Service Bulletin 502

Affected ModelsSpeed Triple ABS Special Edition

SubjectOil Dipstick

1. Old dipstick
2. New dipstick (T1261444)

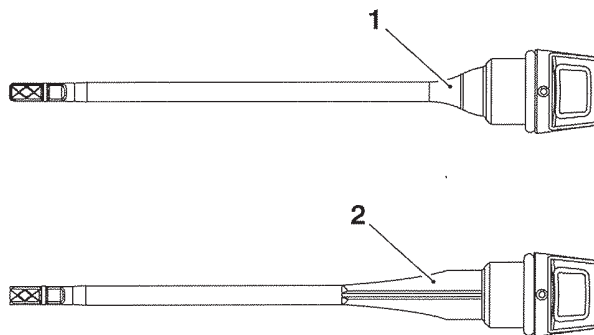
We have identified a need to replace the oil dipstick assembly on the above models. Dealers are requested to remove and replace the oil dipstick assembly.

- If the clutch cover on the above models has been replaced in service for part number **T1261414** (as listed in the EPC), replacement of the oil dipstick assembly is not required.
1. Remove the oil dipstick assembly and replace with the new oil dipstick assembly. See the following illustration for identification of the old and new dipsticks.

Genuine parts1 x T1261444, Dipstick Assembly
